BULLI SEAM OPERATIONS **RESPONSES TO SUBMISSIONS** **PART A - AGENCY SUBMISSIONS**

RESPONSES TO AGENCY SUBMISSIONS

APRIL 2010
Project No. BHPIC-07-01

Responses to Agency Submissions on the Bulli Seam Operations Environmental Assessment

Fig. 4.16 Comparison of Raw Observed Incremental Closure versus Lateral Distances from Edges of the Incremental Panel for All Data, Valley Sites affected by Thin and Cross Bedded Bedrock Strata and Valley Sites not Undermined by Current or Previous Longwalls

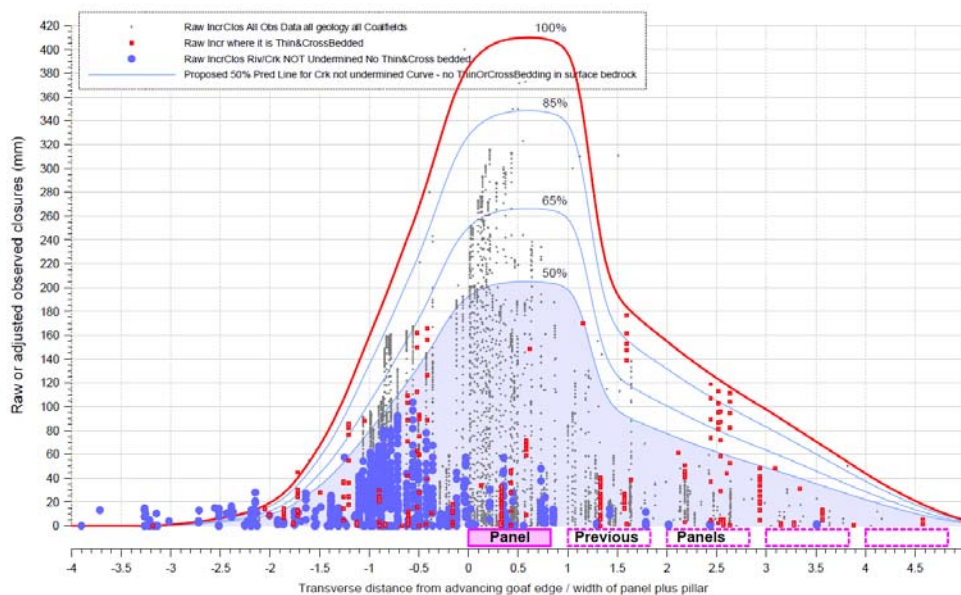
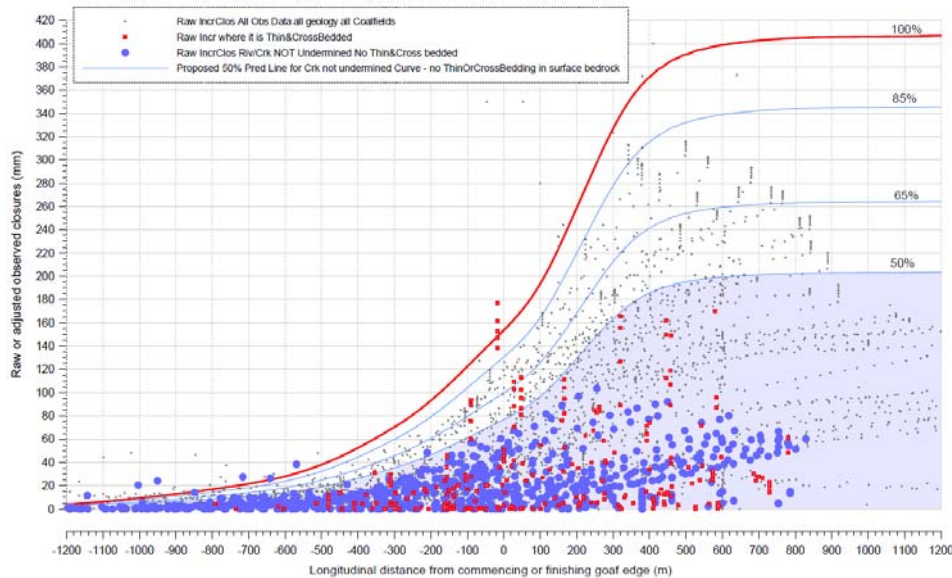
The ACARP Prediction Method provided one set of upsidence and closure prediction curves that was drawn over the then available upsidence and closure monitoring data. Now that the available monitoring database has been extended with many more new cases and, since the recently proposed mine plans involve extracting coal resources up to but not under the creeks and rivers, consideration has been given to the preparation of a new set of upsidence and closure prediction curves using specific “subsets” of the total database.

As indicated in the following two plots, Fig. 4.16 and Fig. 4.17, lower values of upsidence, closure and strain have been observed within those valley monitoring sites that have not been undermined by either the current or the previously extracted longwalls (shown in blue circles), than the upsidence, closure and strain observed in those valleys that have been undermined (shown as black diamonds). Sometimes these reduction factors have been described as the “never undermined subset” factor. The red points shown on these figures are the monitoring points where there is “Known Weak Geology” in the valley base and it is clear that, wherever the geology of the bedrock in the base of the valley comprises thin highly jointed layers, the resulting upsidence and closure can be higher than where the bedrock comprises strong thick homogeneous strata layers.

Research is continuing in this regard, but, it is initially clear from these two figures that a reduction factor of about 0.5 could be applied when predicting upsidence and closure for those creeks or rivers that have not been undermined by the current or previous longwalls. But to be conservative, for now, a reduction factor of 0.7 has been adopted until the ongoing research proves that lower reduction factors would be appropriate.

Figure 94 – AWBM Structure

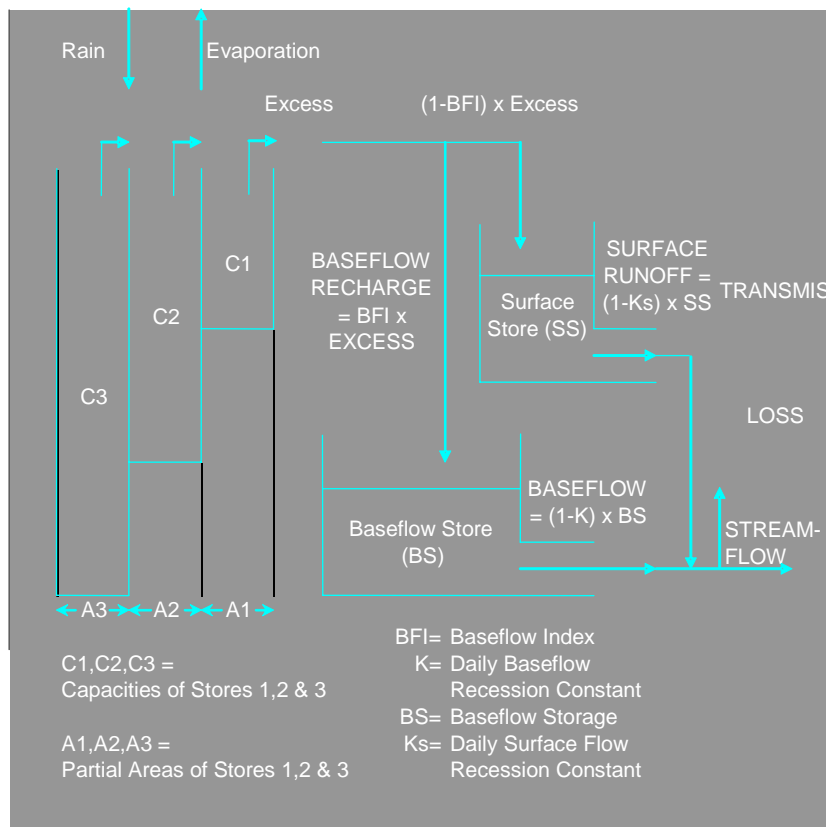
DECCW's comments on the use of baseflow within the AWBM are unclear and appear inconsistent. 'Baseflow recharge' within the AWBM only occurs from the surface stores once they are filled (and spill), with a proportion reporting to the baseflow store of the catchment (in proportion to the baseflow index [BFI]) and the remainder reporting to streamflow (see figure above). The baseflow store of the catchment then slowly discharges with time. The calibration process used in the AWBM means that baseflow in the model incorporates all water which follows slow moving flow pathways in the catchment.

The AWBM is a nationally-recognised catchment-scale water balance model that estimates streamflow from rainfall and evaporation. The structure of the AWBM is illustrated in Figure 94 of Appendix C of the EA:
